CITY OF ALBUQUERQUE

RE: Lot 9 Block 8, Volcano Cliffs, Unit 22, SAD 228 6324 Canavio NW Grading and Drainage Plan Engineers Stamp Date 3/11/19 (D10D003E9)

LOT 9, BLOCK 8, UNIT 11 **VOLCANO CLIFFS** 03-09-2019 GRADING AND DRAINAGE PLAN SHEET # Rio Grande 1 OF 1 Lingineering 1606 CENTRAL AVENUE SE SUITE 201 ALBUQUERQUE, NM 87106 (505) 872-0999

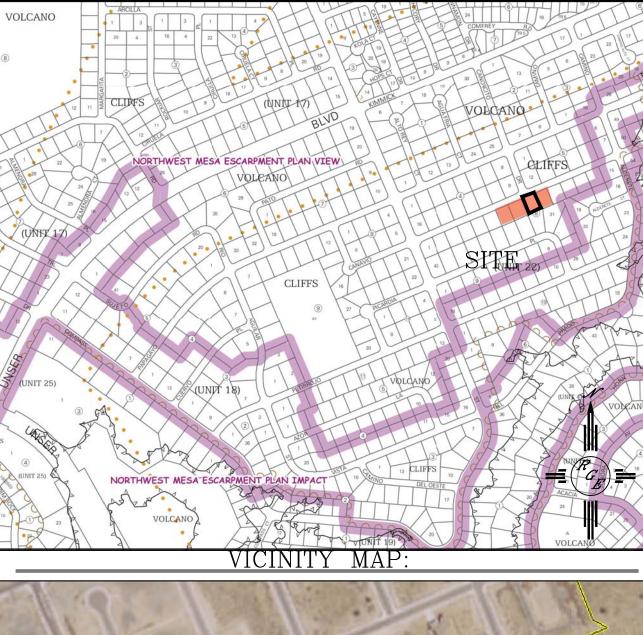
Based upon the information provided in your submittal received 3/11/19, this plan is approved for Grading Permit.

Prior to Building permit approval a Pad Certification will be required, provided by the Engineer or a registered Land Surveyor.

Reiterate to the Owner/Contractor that a separate permit for a garden/retaining wall must be obtained with the approved G&D plan and Pad Certification.

Prior to Certificate of Occupancy release, Engineer Certification per the DPM checklist is required.
